Applicant's A.22(2A)(b) Response Statement to Fingal County Council LRDO081 LRD Opinion

Residential Development at Flemington Lane, Bremeore & Flemington, Balbriggan, Co.Dublin

Prepared by Stephen Ward Town
Planning and Development Consultants
Limited behalf of Lagan Homes
Balbriggan Ltd

Figure 3 Two Strategic Development Phases

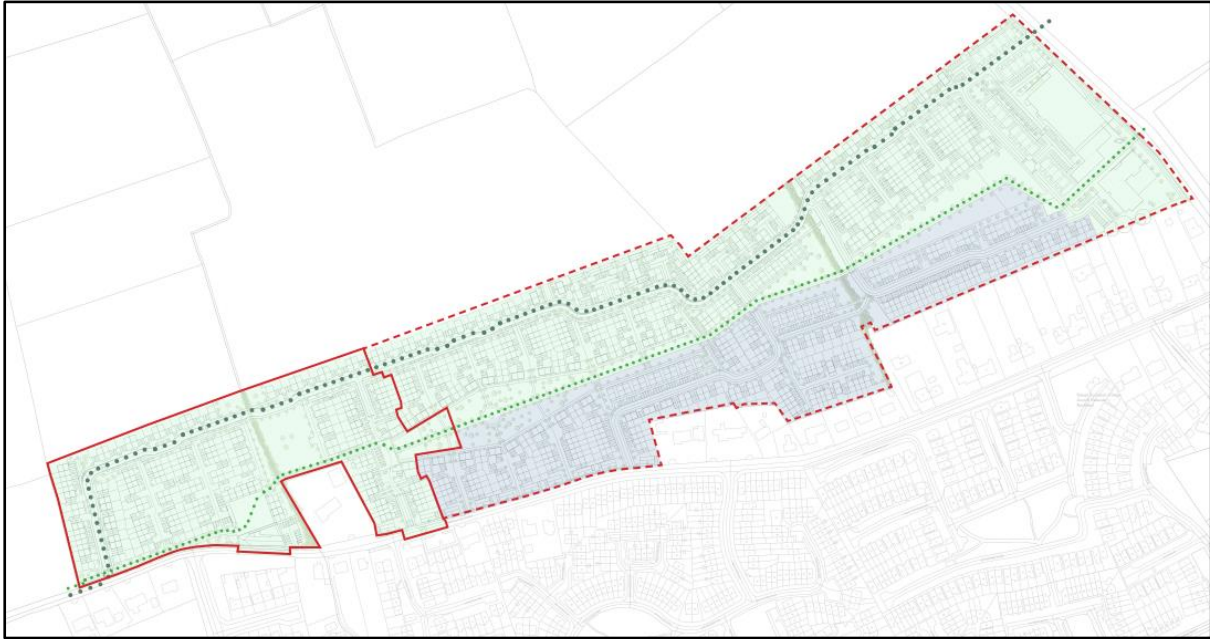
The proposed development is not in accordance with the phasing requirements set out in Chapter 9 of the 2024 Flemington Local Area Plan (LAP) as the current proposal will not deliver the central active travel spine and new link street as part of the overall development proposals brought forward in Phase 1. It is noted earlier discussions between the applicant and the Planning Authority included proposals for the development of the entire LAP lands in a more comprehensive manner. The LAP requires that both the central active travel spine and new link street are provided as part of the overall development proposals brought forward in Phase 1 and, as such, the current proposal would be contrary to the phasing requirements of the LAP.

As discussed at s.247 and stage 2 meetings, two strategic phases are proposed by the applicant in line with the LAP requirements to ensure provision of physical and social infrastructure in tandem with residential development. The illustration below summarises the proposed 2 no. strategic phases, which provide for the delivery of all the scheduled infrastructure in table 9.1, in the appropriate phase, in accordance with the LAP objectives and in tandem with residential development. The applicant again wishes to emphasise that Both the Link Street and Active Travel Spine are in Phase 1.

As acknowledged at section 8.1 of the Opinion Report, the applicant is the landowner of the entire LAP area providing significant advantages for the coordination of physical and social infrastructure provision in tandem with housing development. Preplanning consultation has commenced for a second planning application for the balance of the LAP lands (LRD0090) and a context drawing that accompanies this planning application demonstrates the fully integrated approach to the development of the total landholding. The phasing applied (figure 3 above) will achieve all the objectives contained in Table 9.1 in the required phase.

Figure 7 Illustration of Enclosure on Link Street as proposed

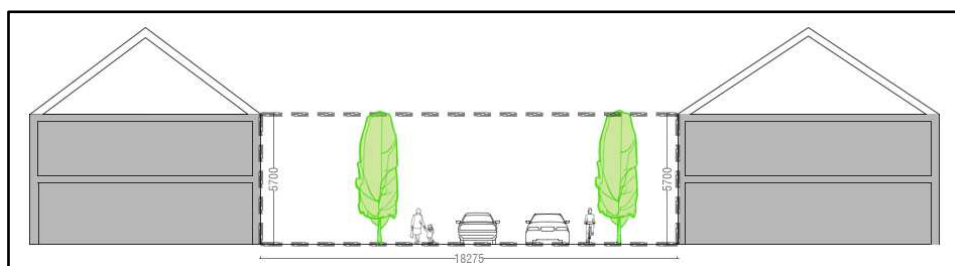
The proposed Flemington LAP Development Layout detailed in Figure 3.1 of the LAP provides for strong urban frontage onto the new link street whereas the current proposal fails to achieve this due to the provision of two storey detached dwellings. This is not acceptable. The applicant is advised their proposals should be significantly revised to provide for appropriate strong urban frontage onto the new link street. This is required as part of any future LRD application.

Section 4.2.1 details building height and street width ratios. In compliance with DMURS, the link street is designed to have moderate enclosure as detailed by figure 4.7 of DMURS.

As stated above, the design of the link street adheres to DMURS and includes housing on both sides of the street to provide enclosure. Two storey detached dwellings are provided at the entrance to the link street and where the link street turns east. These buildings act as design cues with dual frontage turning each corner. the detached houses are repeated along the northern boundary in acknowledgement of the approach to the retained hedgerow and townland boundary and using their dual frontage to overlook public open space. The remaining house types are terraced and semi-detached. Street trees are also proposed. It is submitted that the provision of houses on both sides of street creates strong urban frontage. It is also submitted that the ‘tightness’ of the street and the relationships between buildings and the street, punctuated by open space, also creates strong urban form. As detailed in the Architects Design Statement by JFOC, material placement has been carefully thought out to positively define the public realm and provide visual interest.

Figure 8 Extract from the DMURS Compliance Statement by Waterman Moylan

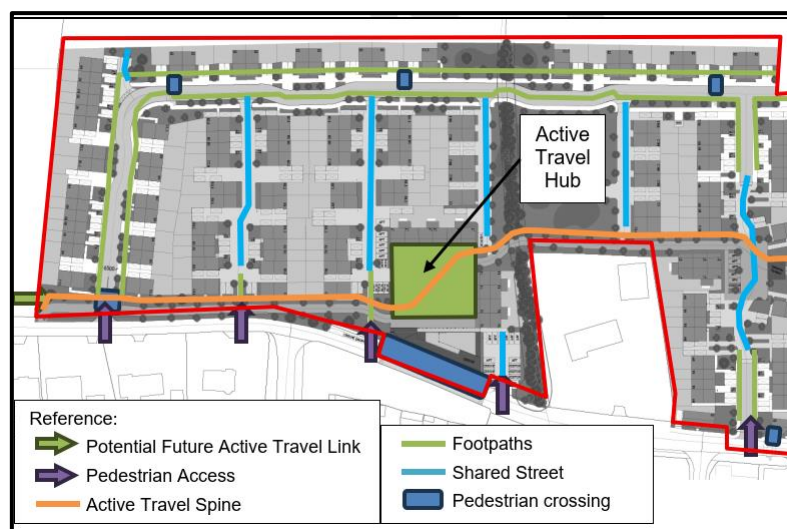
The proposed route of the new link street differs from that required by the LAP. Notably there are larger quantity of units proposed to the north and west of the proposed link street than shown on the LAP Layout, including a crèche unit. The LAP shows a smaller number of units to the north of the link street in the centre of the site. The proposed houses along the entirety of the western and northern side of the new link road are not acceptable as this layout is not in accordance with the layout plan of ‘Character Area 4’ of the LAP. Additionally, the layout as proposed provides unnecessary segregation of a significant number of houses from active travel route, open spaces, and community facilities. The applicant is advised significantly revised proposals are required in this regard.

There are 16no. houses proposed along the northern boundary of the link street and 15no. along the western boundary (total 31no). As stated above, it is not the intention of the LAP to be overly prescriptive in nature. There are a number of justifications for the location of housing on both sides of the link street, including compliance with DMURS as outlined at section 2.0 of this Statement, not to mention a single sided street being a very poor use of infrastructure. The LAP does not prohibit housing both sides of the link street. The LAP contains many references to it being a flexible and non-prescriptive document. Section 5.2 of the LAP dealing with Character Areas states *“As referenced indicative development layouts are provided for each character area”*. The notation to Figure 6.7 states – *“Link Street, Cross section details (indicative)”*.

Segregation: The housing along the west and north of the link street is a short walking distance from community facilities, public open space and the future active travel route. Crossing points are provided along the Link Street with full footpath connective through local streets providing safe routes through to the plaza, active travel hub and crèche as well as the central public open space containing the MUGA. The proposal has been subject to independent review by Roadplan and there was no issue raised in relation to locating housing north or west of the link street. Further details on the pedestrianised surfaces and connectivity can be found in the documents by JFOC Project Architects, Waterman Moylan Consulting Engineers and NMP Landscape Architects for the project under separate cover.
